Vision Zero Action Plan

Supplemental Report

CITY COUNCIL STAFF REPORT

Implementation of an on-street two-way Class IV bike lane on Vista Drive and Forest Avenue (Alternative 3) along the Lawson Middle School frontage and prohibition of parking along the west side of Vista Drive between Forest Avenue and Merritt Drive for the accommodation of Class IV bicycle lanes and adoption of an Ordinance Municipal Code Table 11.24.150, relating to prohibition of parking along certain streets.

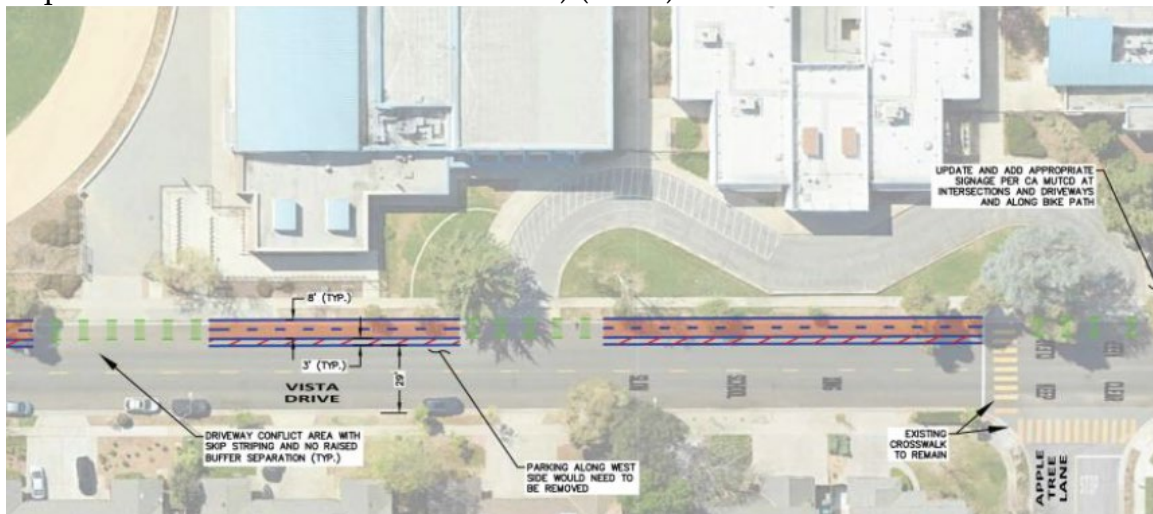
Q6: What improvements are planned or already implemented for the intersections in the north and south entrances to the two-way bikeway to guide bikes from normal one-way bikepath to the 2-way bikeway on Vista? **(Chao)**

Staff response: Improvements would be implemented with the project and include enhanced green bike crossing markings and signage.
